**RESOLUTION NO. R26-67**

A RESOLUTION OF THE MAYOR AND COUNCIL OF THE CITY OF COLUMBUS, NEBRASKA, APPROVING CHANGE ORDER NO. 1 TO THE CONSTRUCTION CONTRACT WITH RUTJENS CONSTRUCTION, INC. IN THE AMOUNT OF \$17,854.85 FOR CHANGE PROPOSAL REQUESTS 1 THROUGH 5 FOR COLUMBUS NORTH WELL NO. 20 PROJECT.

## CHANGE ORDER NO. ONE

Owner: City of Columbus, Nebraska  
Engineer: HDR  
Contractor: Rutjens Construction, Inc.  
Project: Columbus Well No. 20

Proposal Request 03 – Figure 20D101

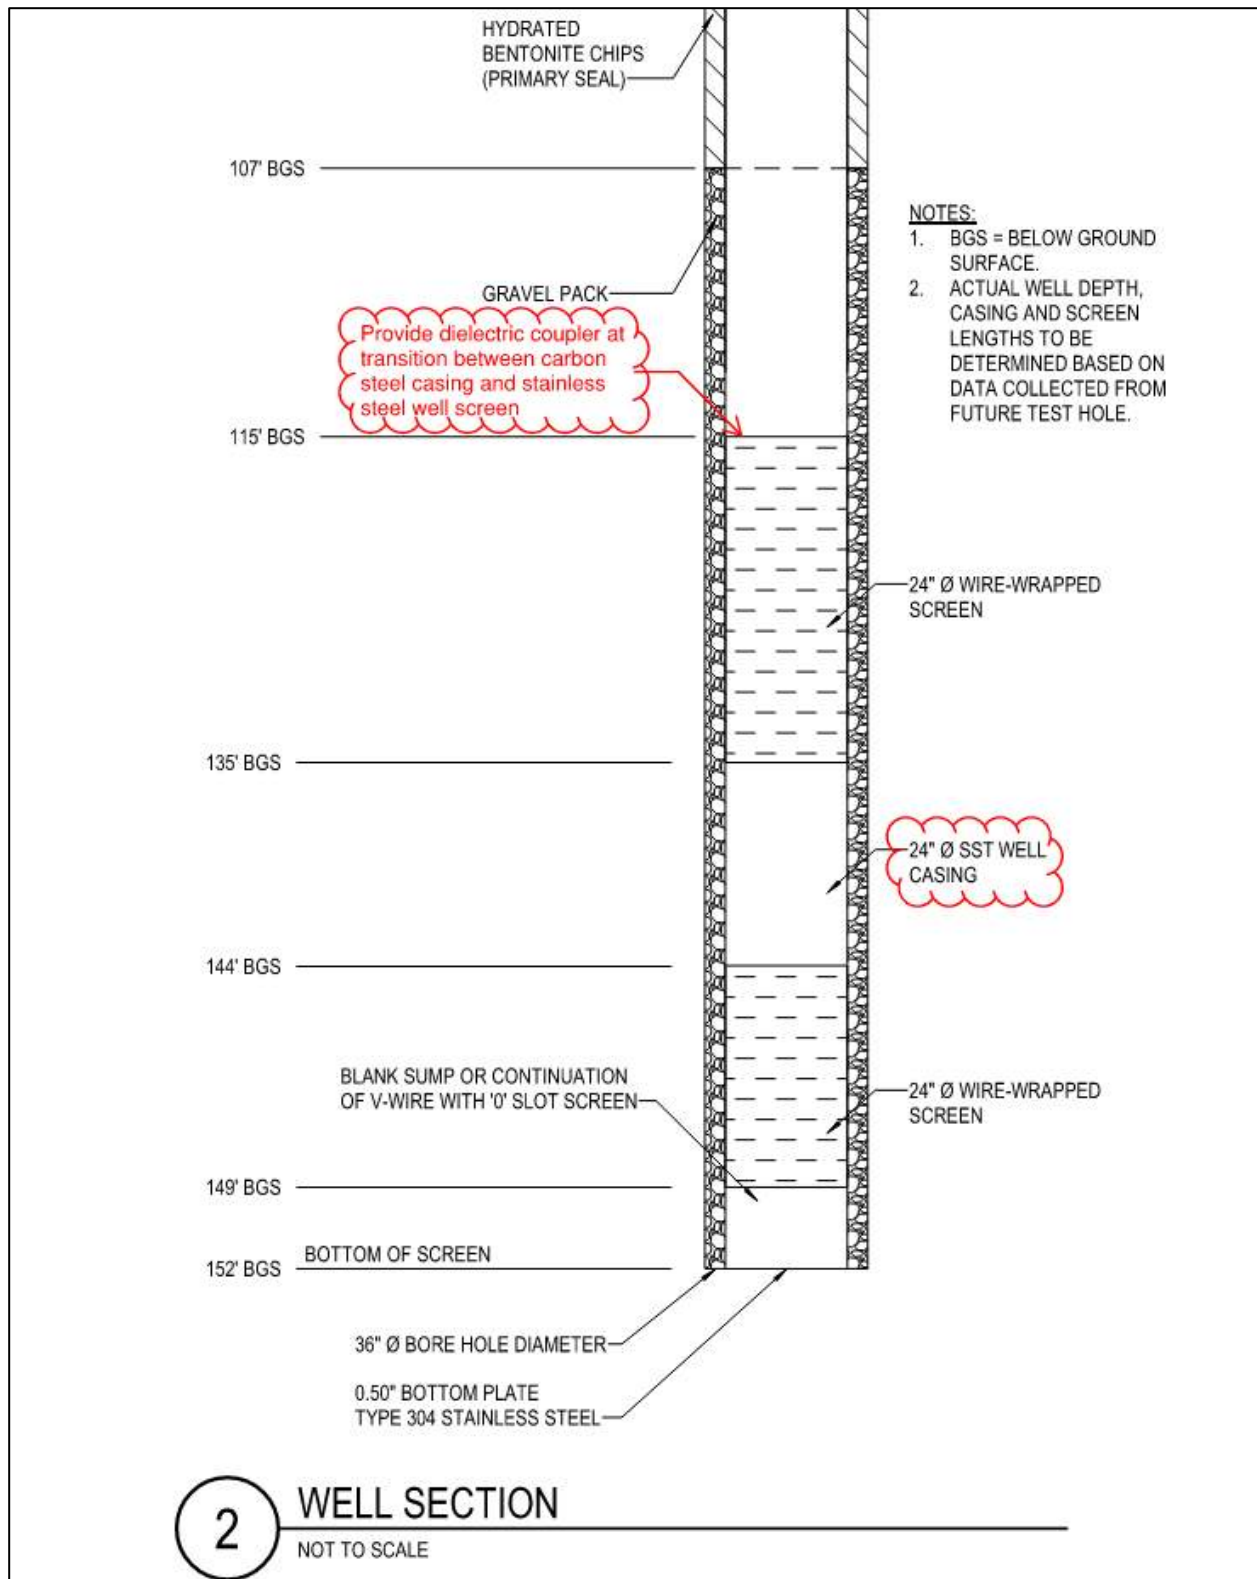
1. Provide and install a dielectric coupler at the transition between the carbon steel well casing and the stainless steel well screen, located at approximately 115 feet below ground surface. Replace the 24-inch diameter, 0.50-inch-thick carbon steel well casing with 24-inch diameter, 0.375-inch-thick stainless steel well casing between 135 and 144 feet below ground surface. See attached Figure CPR01-20D101.

| FILENAME | 10425904-05-SA.rvt | SHEET | 20A101 |

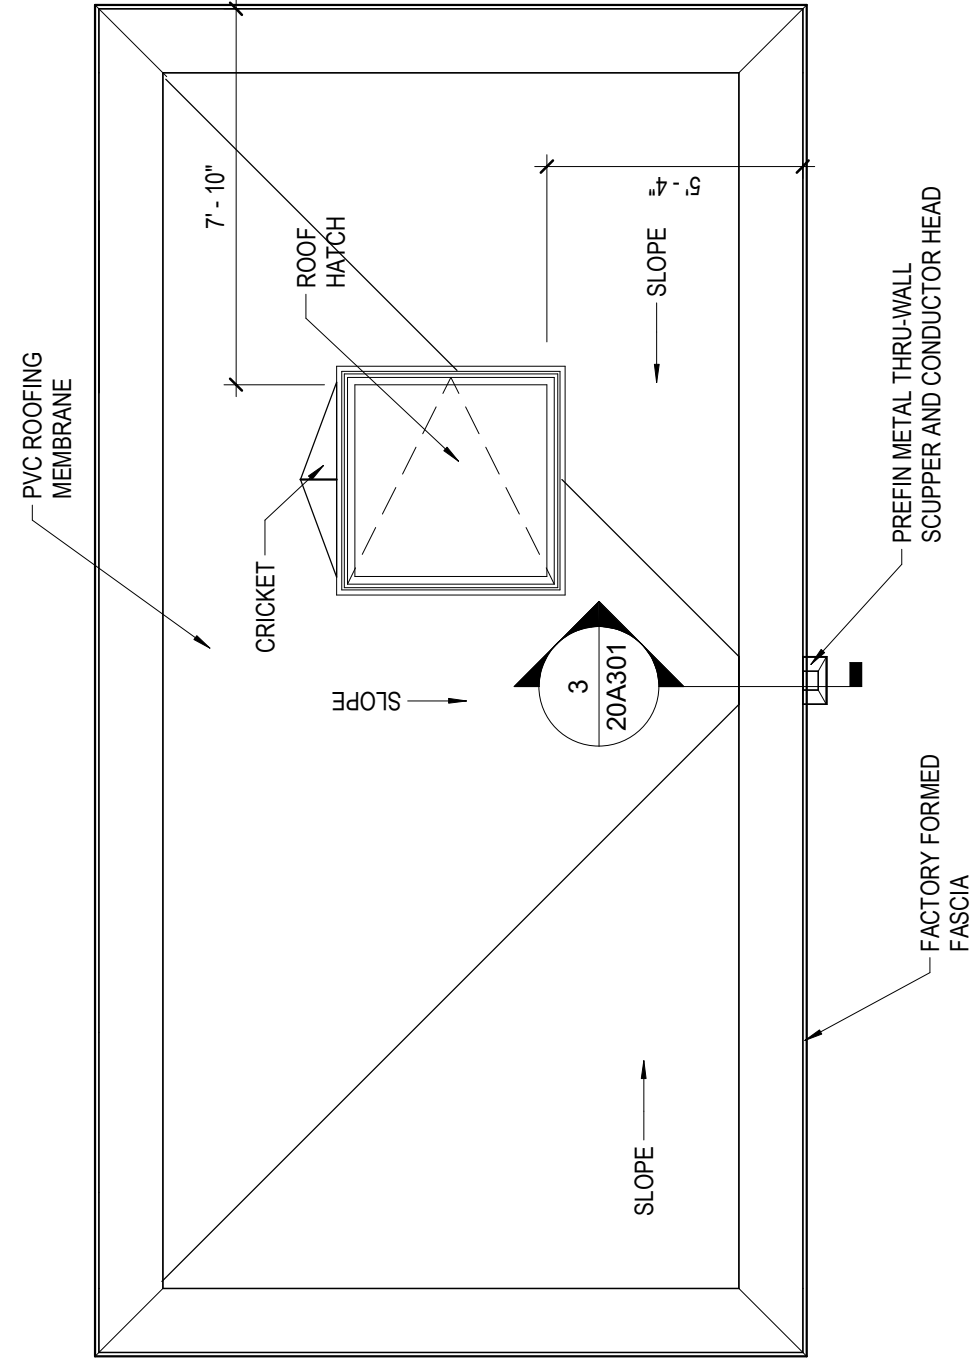
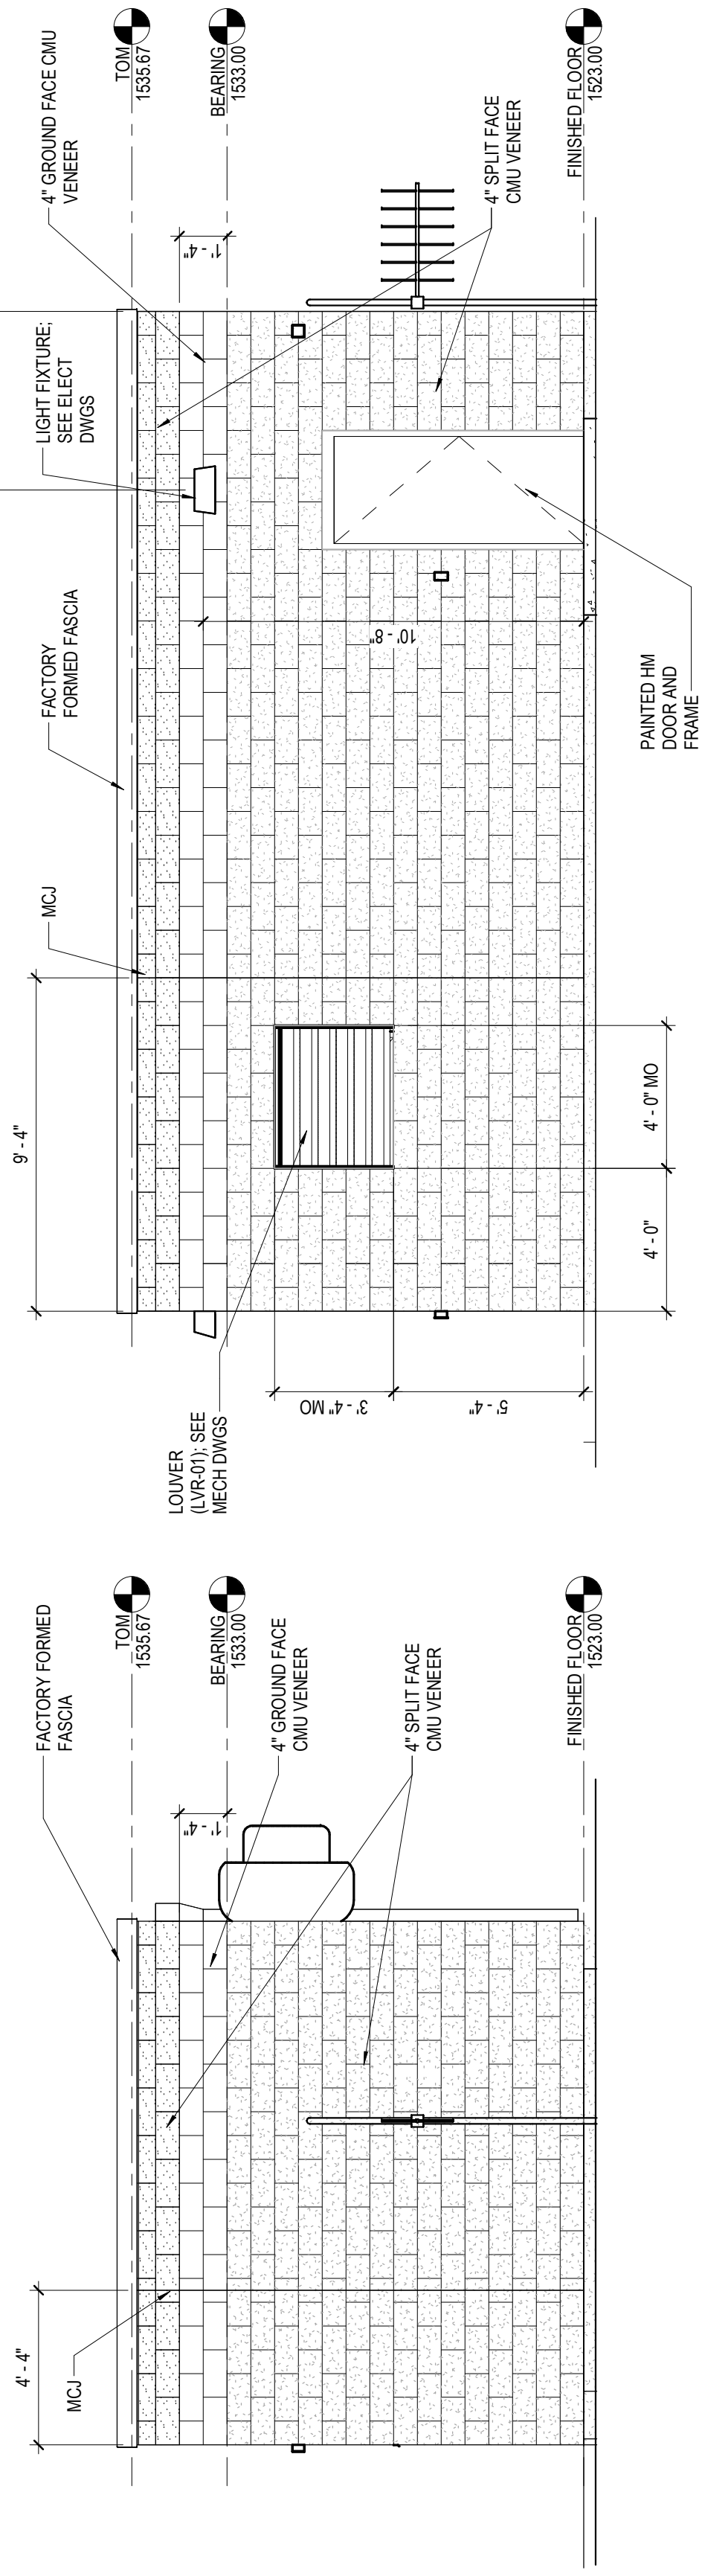
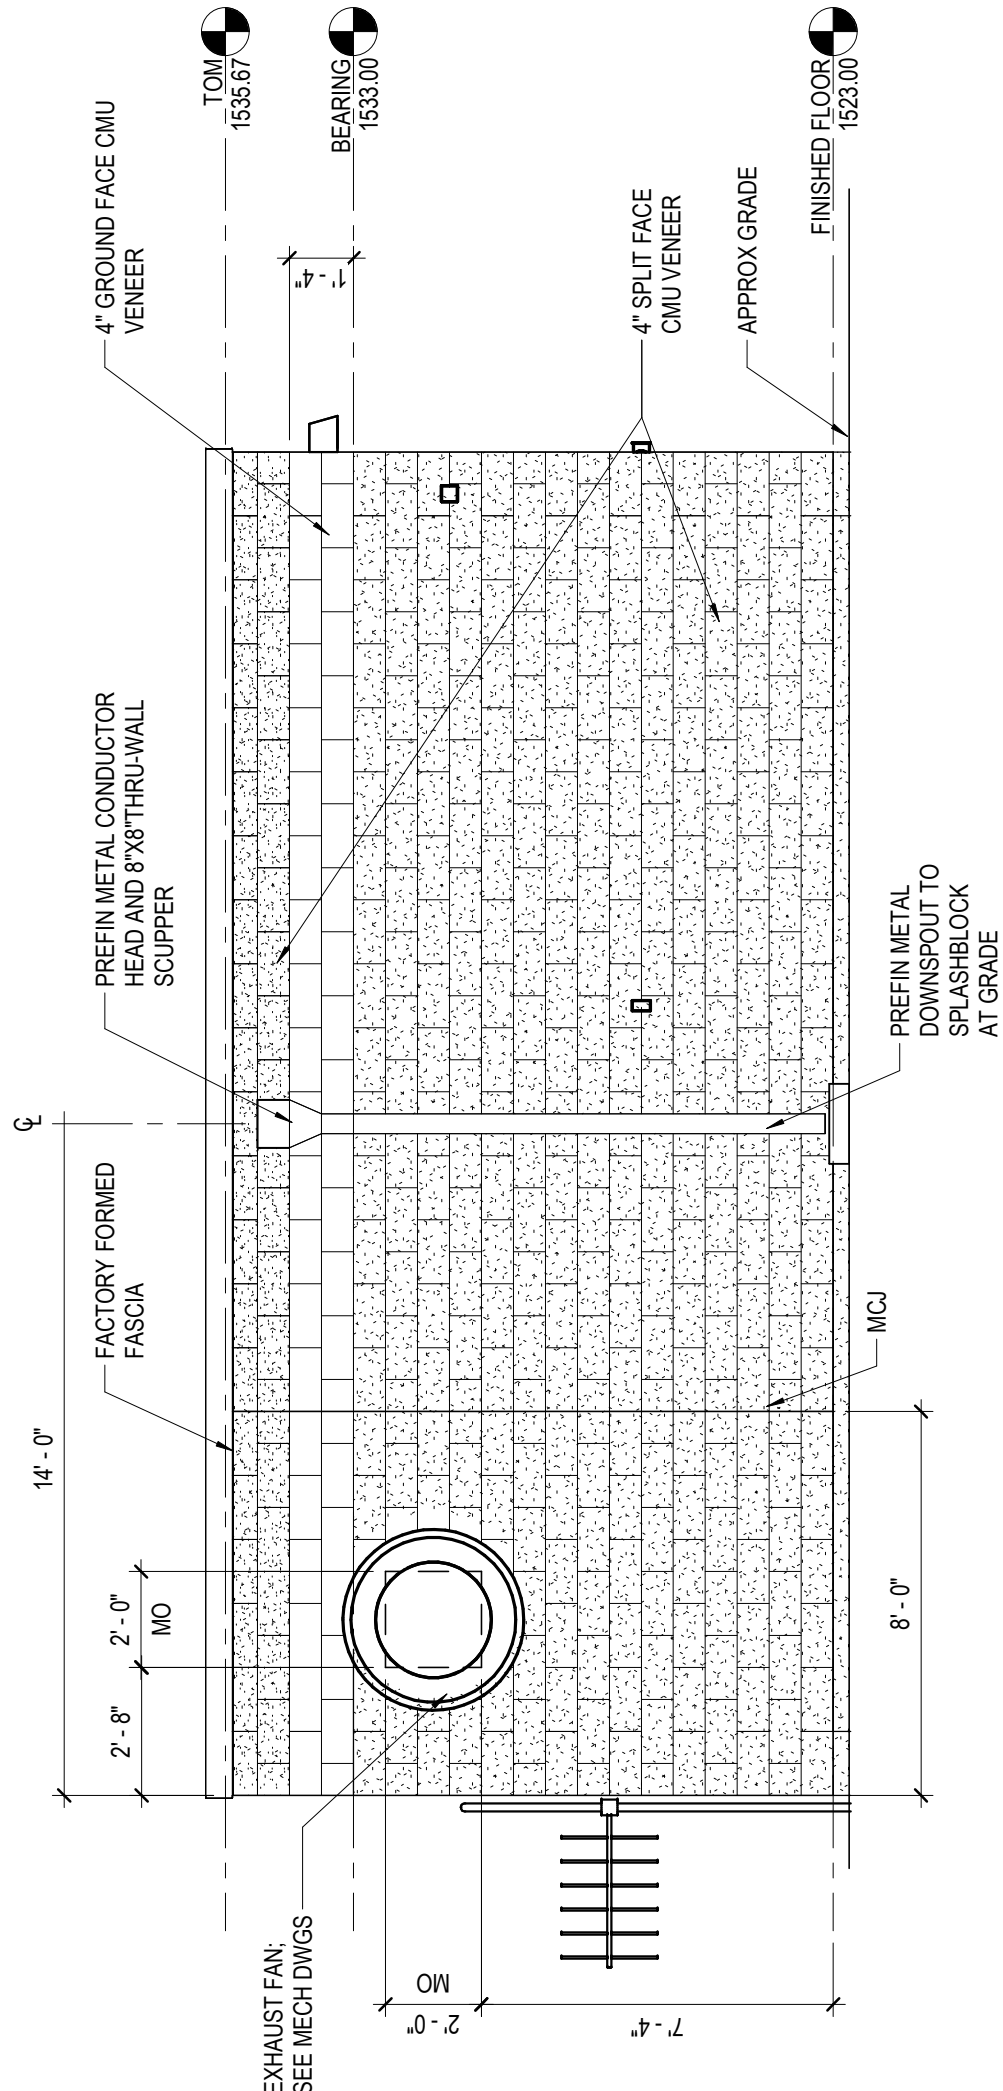
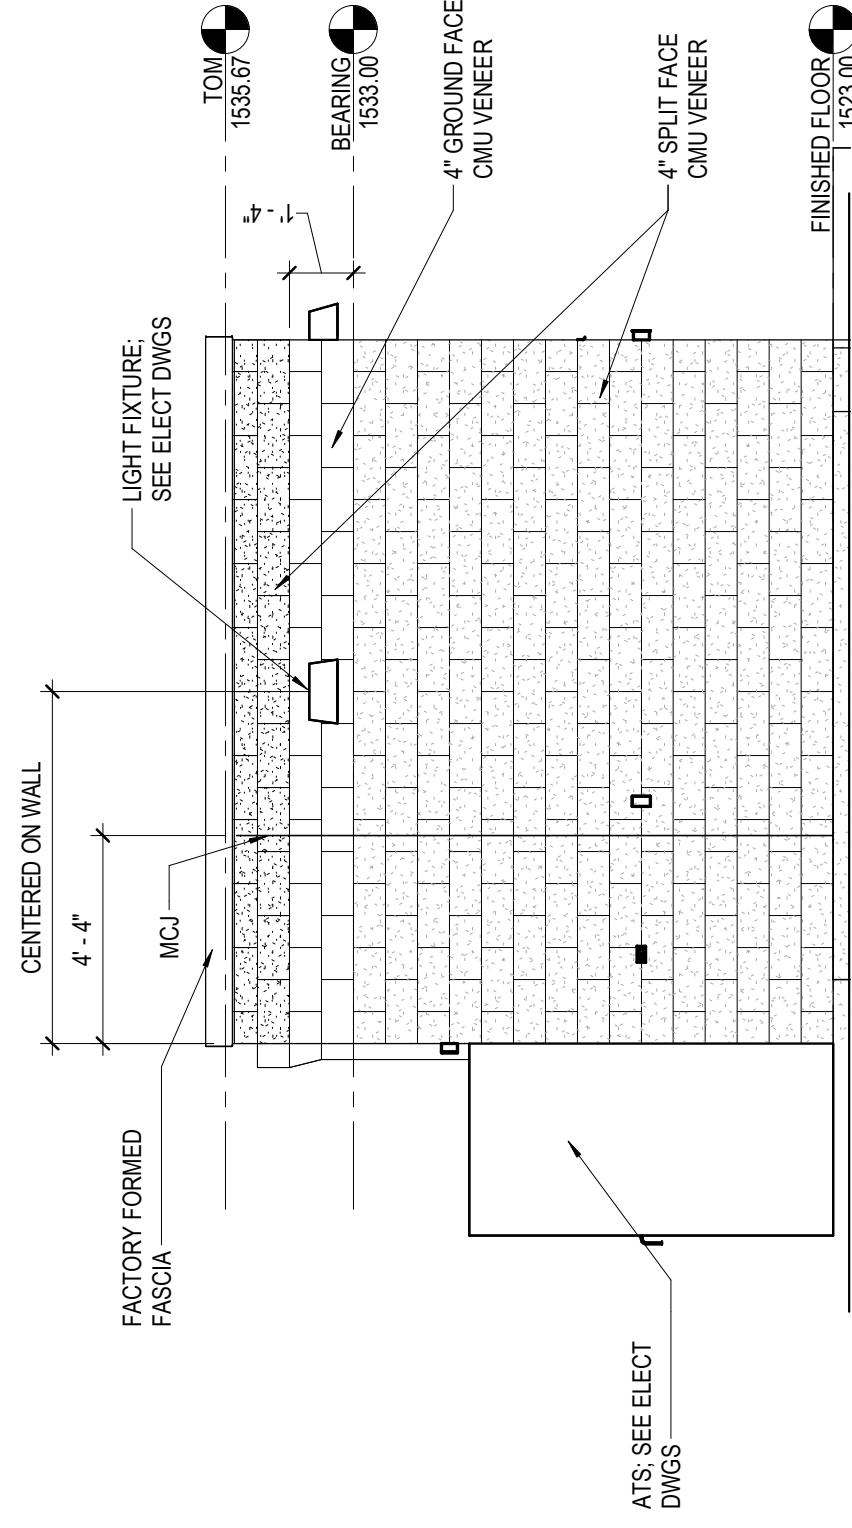
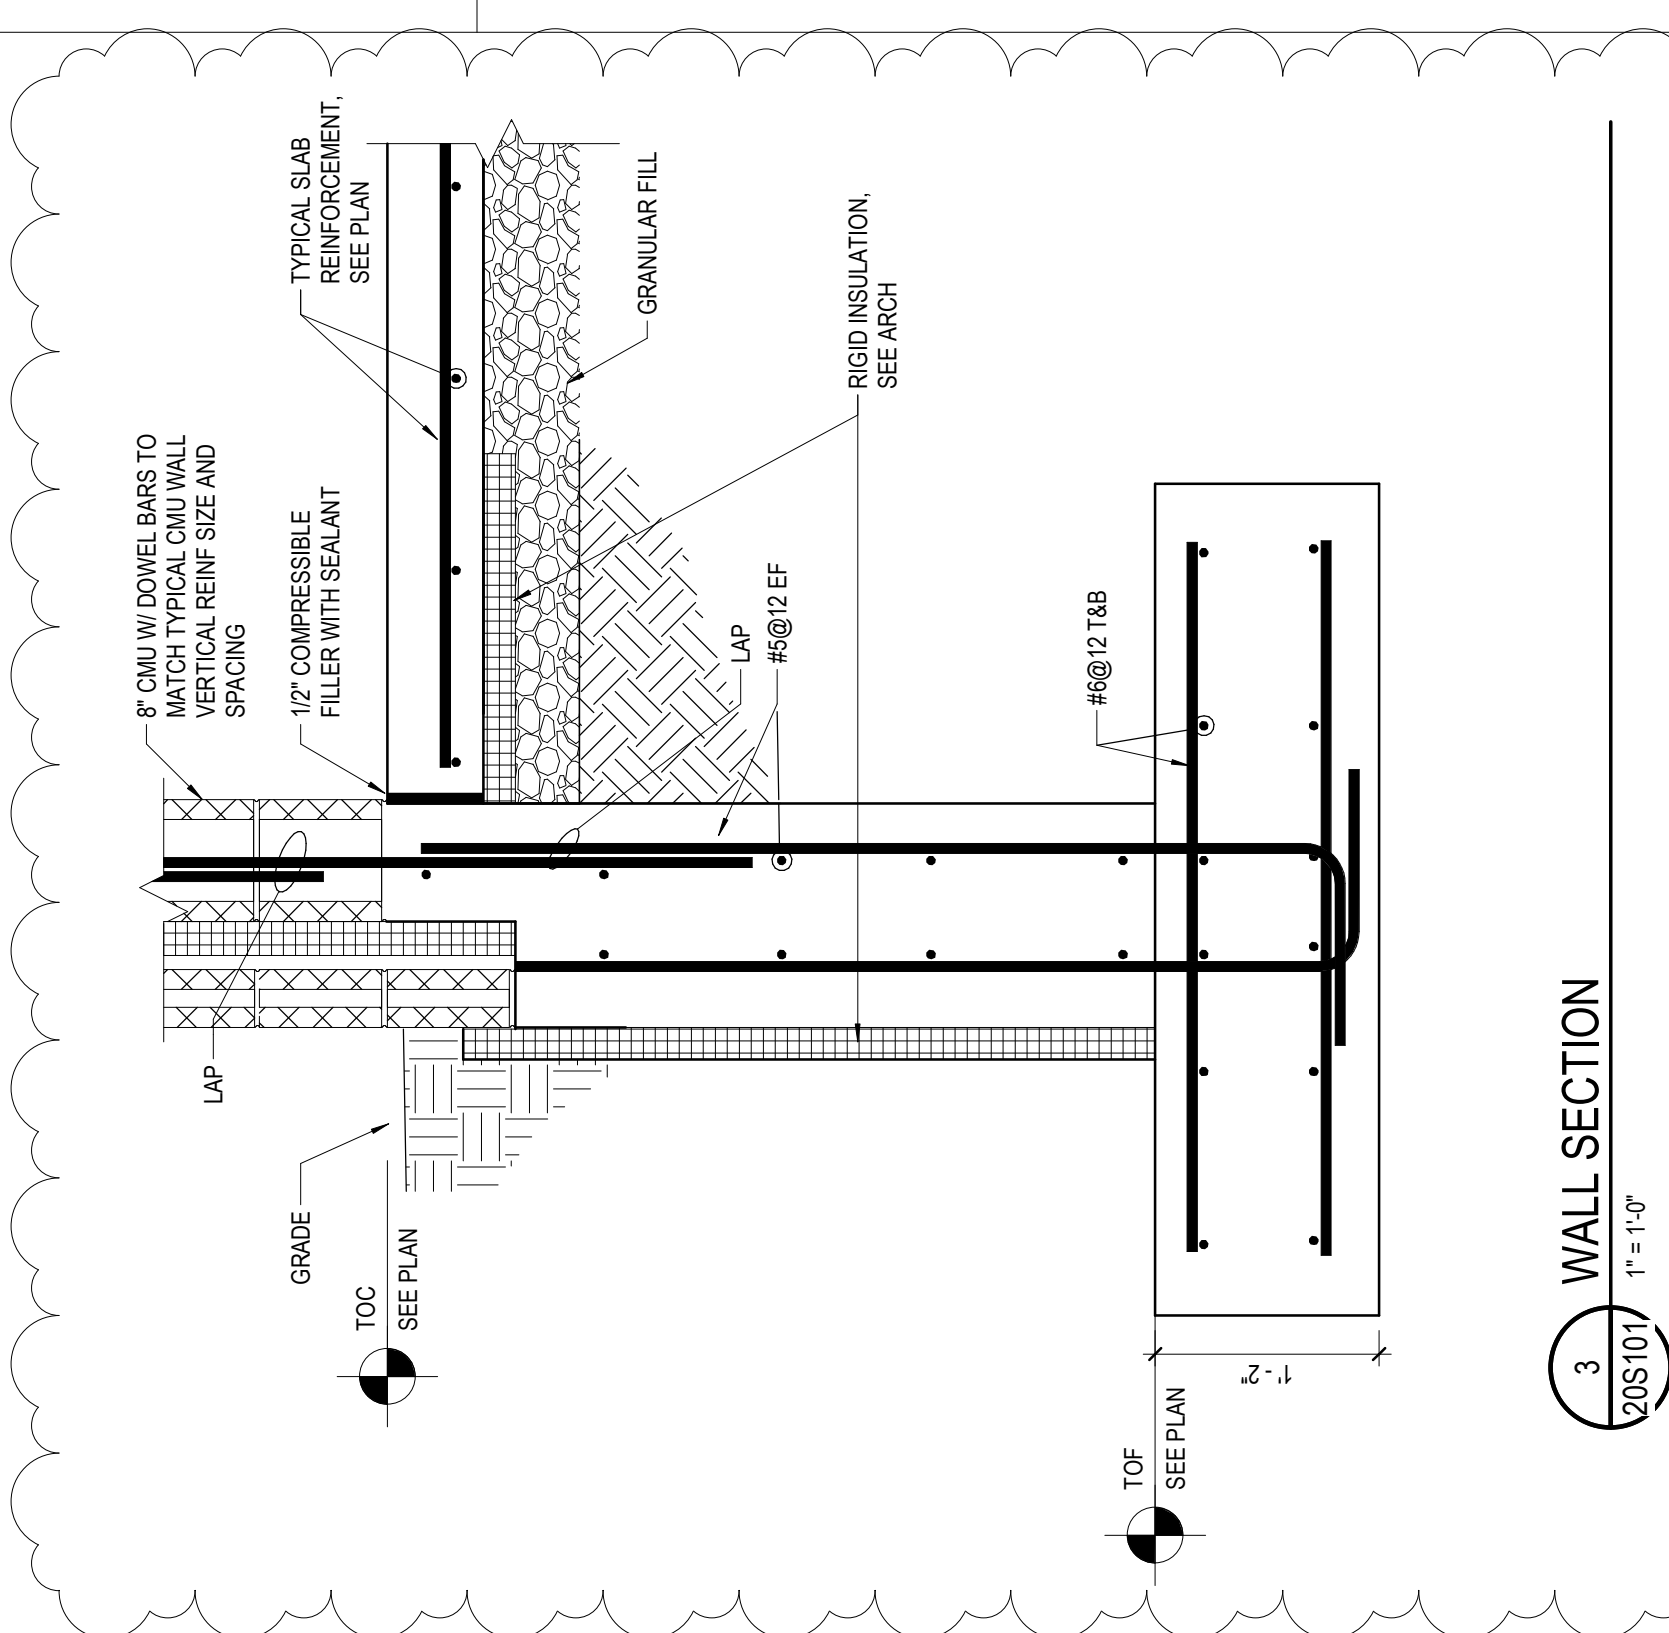
1. Revise the wall section for Well No. 20 as shown on the attached plan sheets dated 3.18.2026 for CPR No. 5.
